ADDENDUM 1

DATE: April 18, 2024

PROJECT: OUSD, Wagner Ranch Elementary School Path of Travel Work

FROM: HKIT Architects

DRAWING TITLE
 ACCESSIBLE RESTROOMS - REFERENCE PLANS & INTERIOR ELEVATIONS

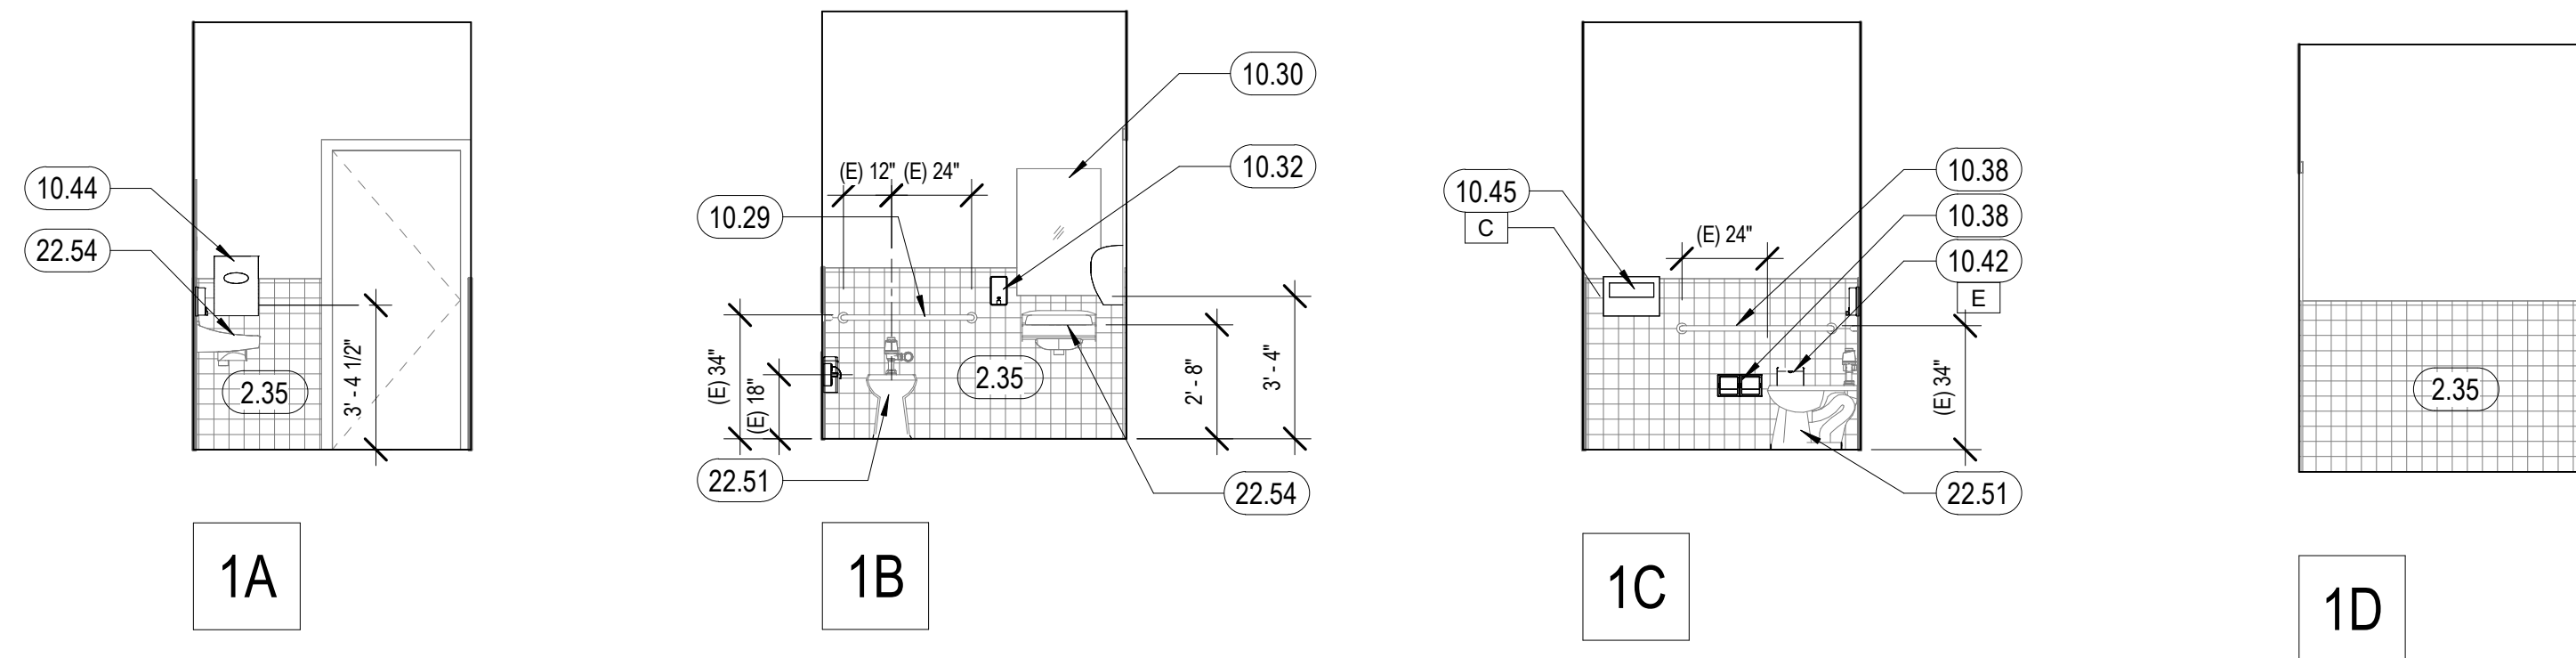
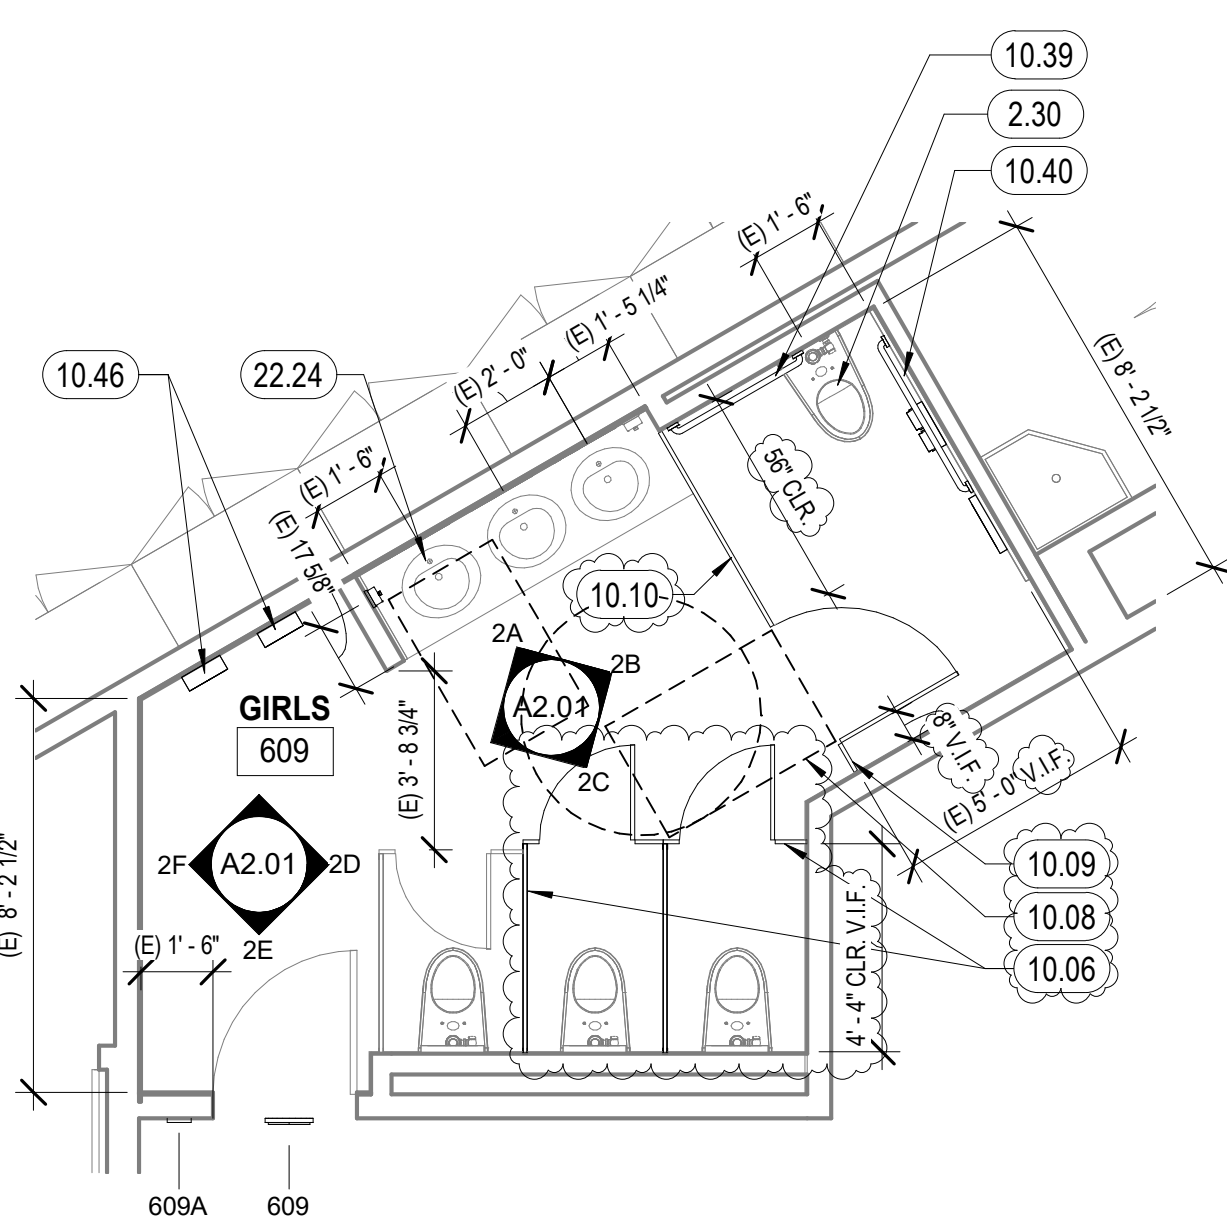
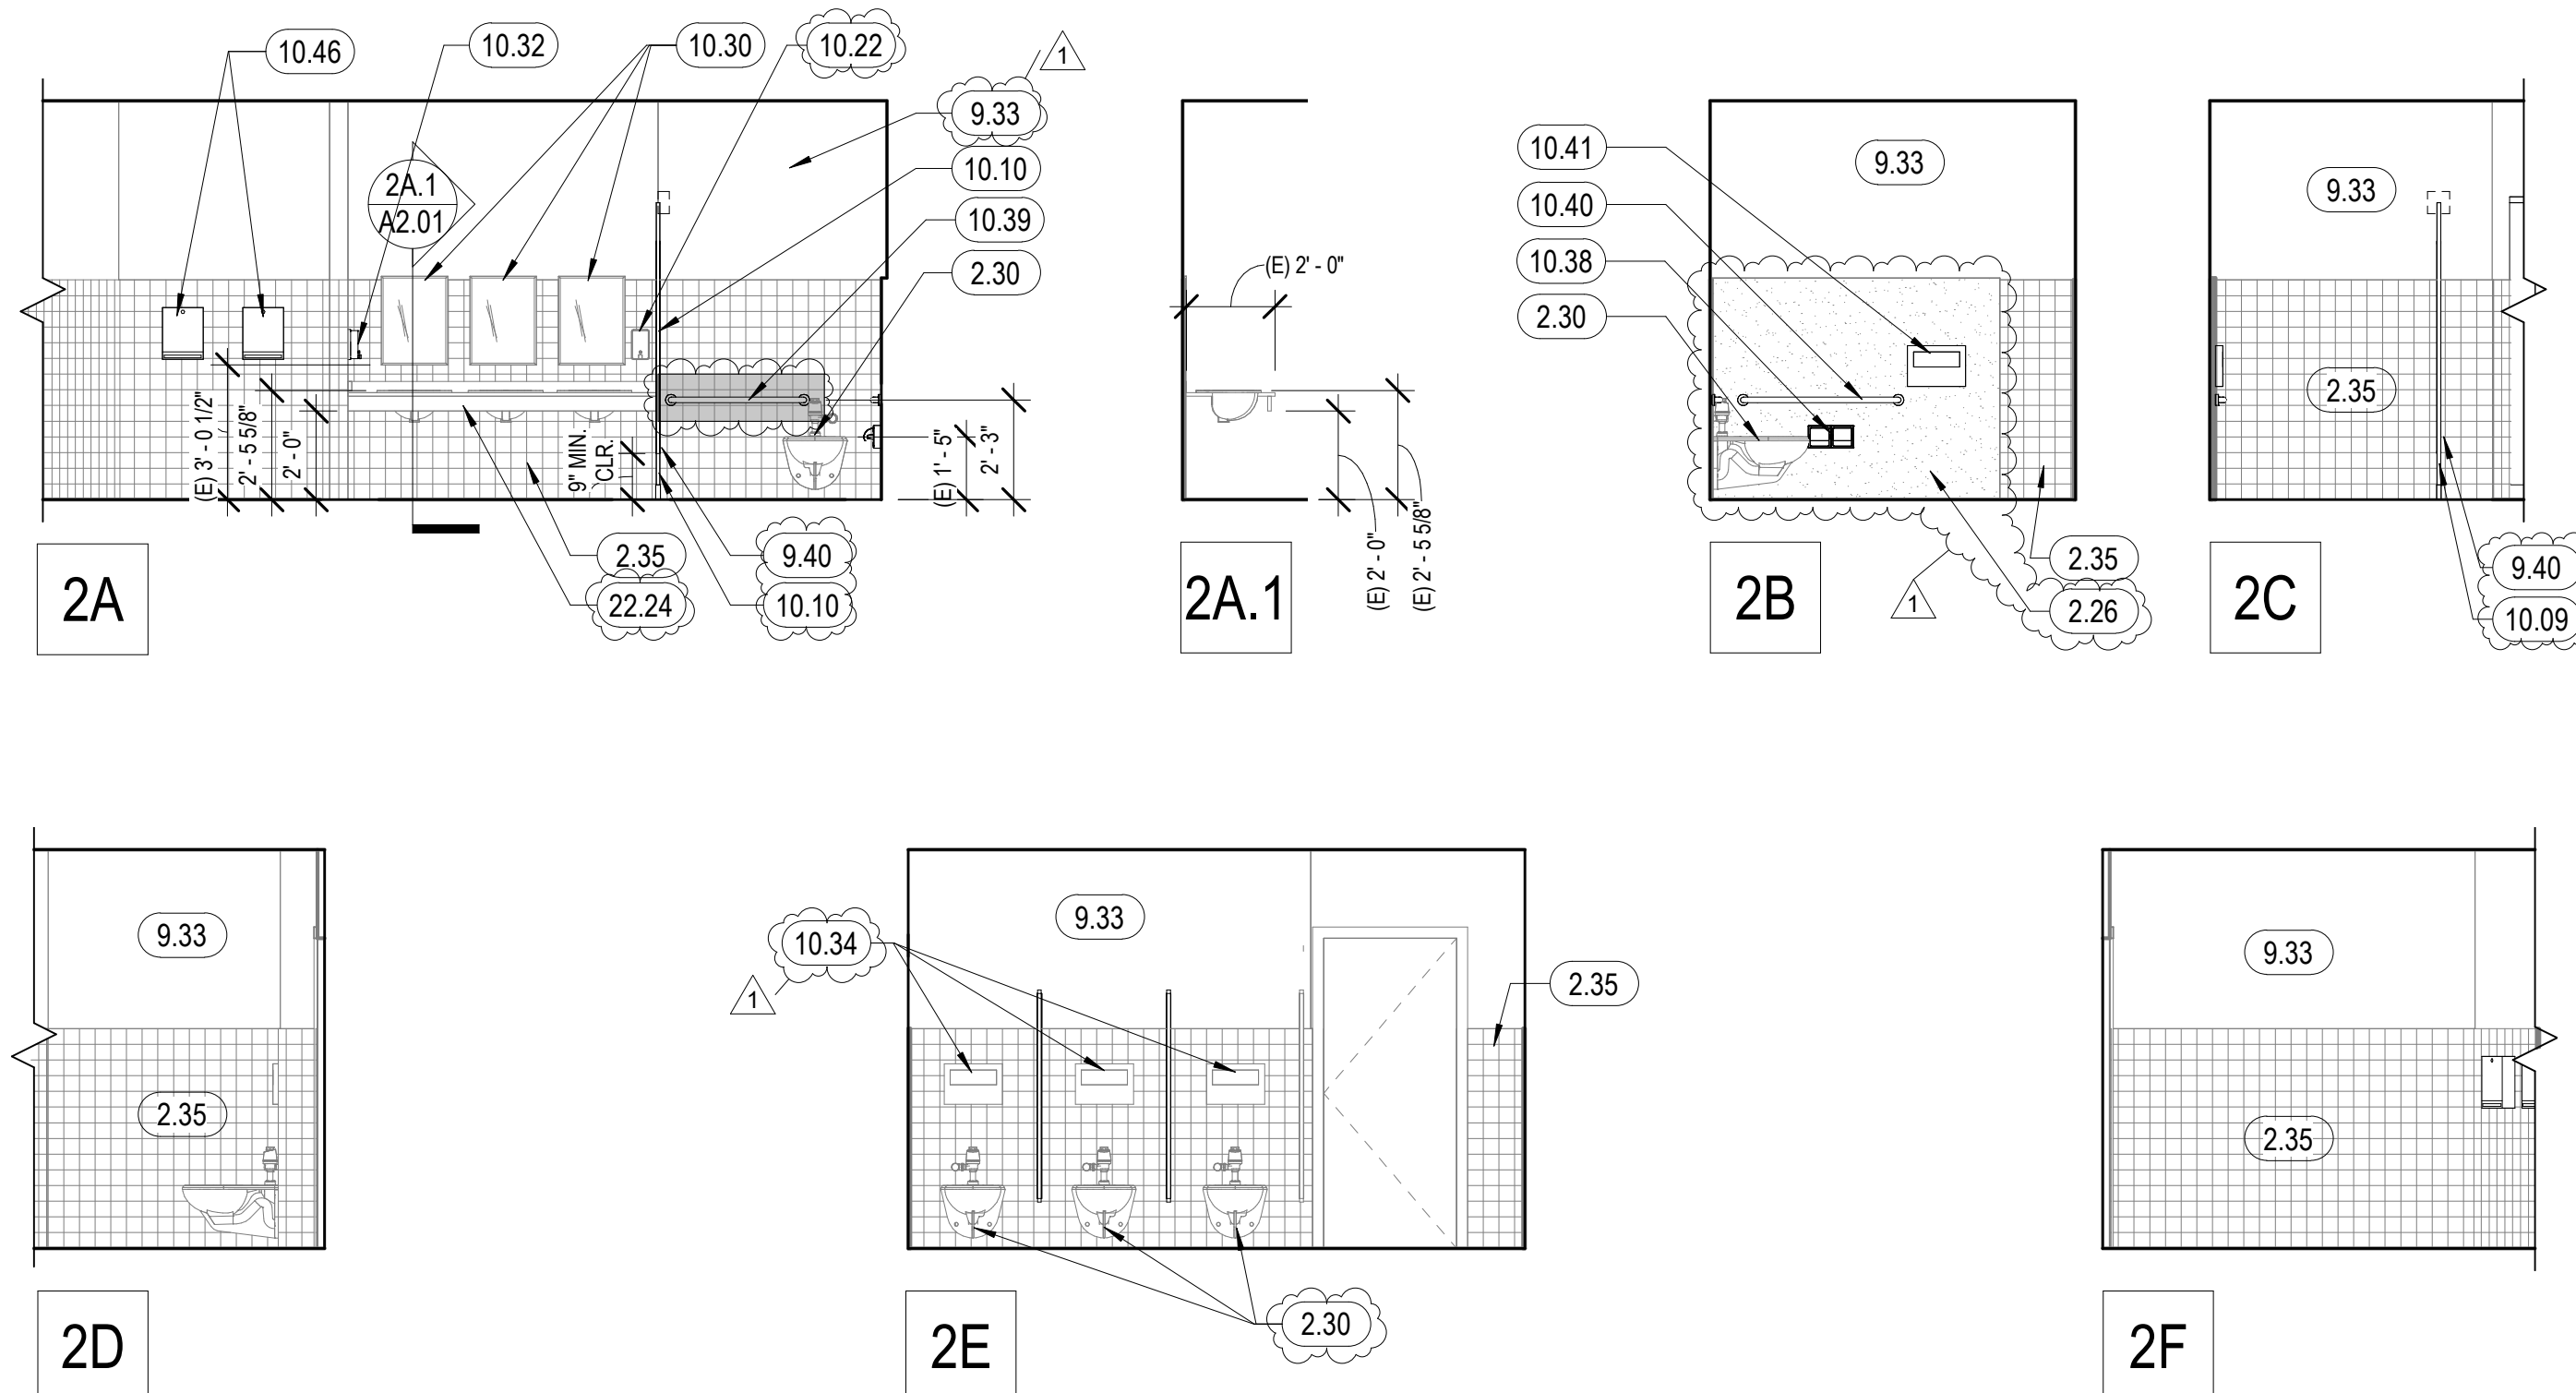
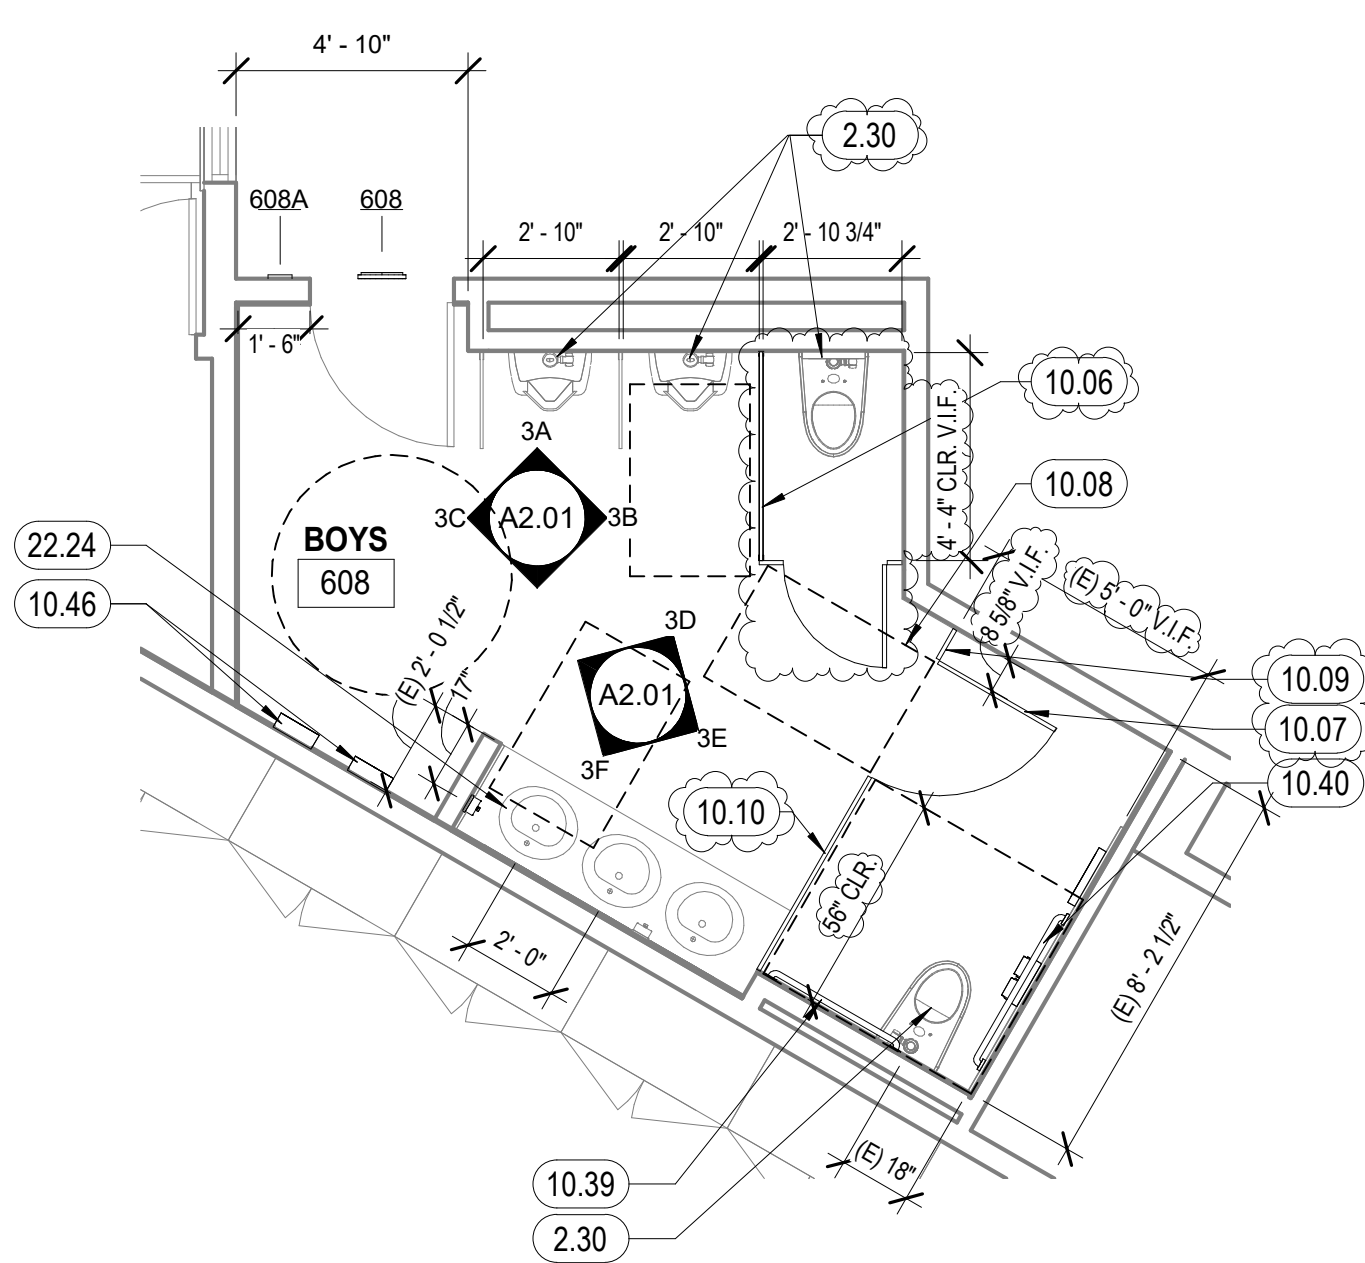
1-3 Subject: Accessibility upgrades at toilet rooms.

Description of Change: Provided additional dimensions and keynotes to clarify scope and required changes to toilet rooms. Revised blocking details for accessories and grab bars at A2.03
